- **TRANSMISSION—E4OD AND C6—INSTALLATION INSTRUCTIONS FOR “NEW UNITIZED PLASTIC CAGE” LOW ONE-WAY CLUTCH—1989-94 MODELS WITH E4OD AND ALL MODEL YEARS WITH C6**
- **TRANSMISSION—E4OD AND C6—NO FORWARD ENGAGEMENT—SERVICE TIPS FOR INSTALLING “NEW UNITIZED PLASTIC CAGE” LOW ONE-WAY CLUTCH—1989-94 MODELS WITH E4OD AND ALL MODEL YEARS WITH C6**

**Article No.  
94-8-20**

**FORD:** 1989-1994 BRONCO, ECONOLINE, F SUPER DUTY, F-150-350 SERIES, F-53

Figure 1 - Article 94-8-20

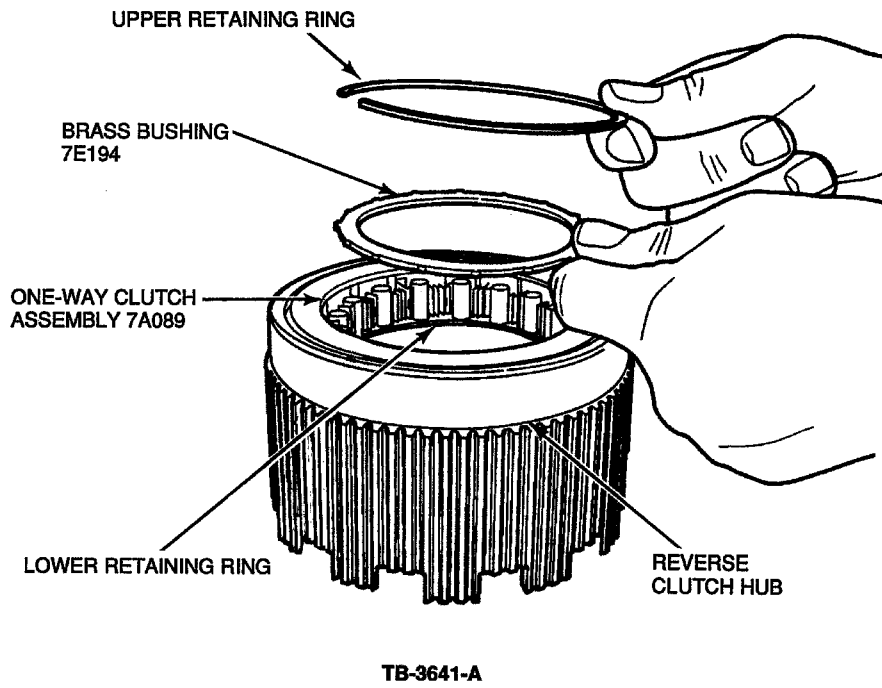
1. Remove the upper retaining ring, brass bushing, one-way clutch assembly and lower retaining ring, Figure 1.
2. Discard all removed parts.

**DO NOT USE BRASS BUSHING (7E193) OR UPPER AND/OR LOWER RETAINING RINGS WITH THE “NEW UNITIZED PLASTIC CAGE” LOW ONE-WAY CLUTCH. THE TABS ON THE CAGE WILL HOLD THE CLUTCH IN PLACE.**

Figure 2 - Article 94-8-20

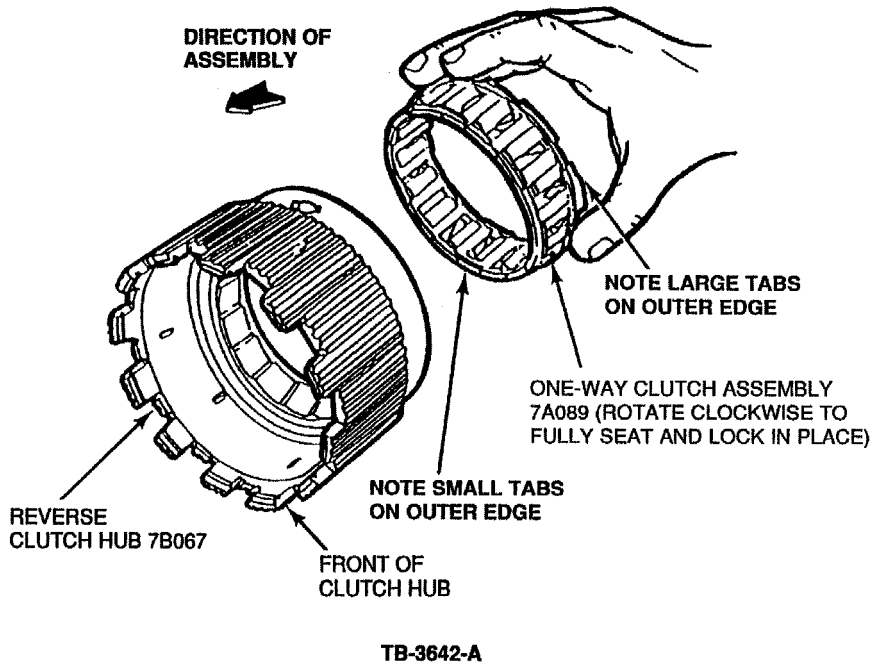
2. Rotate the One-Way Clutch Assembly clockwise to lock tabs on “Plastic Cage” and fully seat the One-Way Clutch in place, Figure 2.
